Title: Comment Resolution for the MR-O-QPSK PHY

Date Submitted: July 15, 2010

Source: Michael Schmidt - Atmel (email: michael.schmidt@atmel.com)

Re: Task Group 15.4g LB51 comment resolution
Abstract: Comment resolution for the MR-O-QPSK PHY

CID 1470

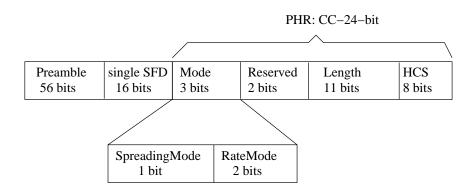
Comment:

During PHR reduce spreading gain but introduce FEC.

- ▶ FEC based on terminated and interleaved convolutional coding
- Option B
- pilots in order to simplify Viterbi decoding
- For details see doc # 15-10-0435-02-004g
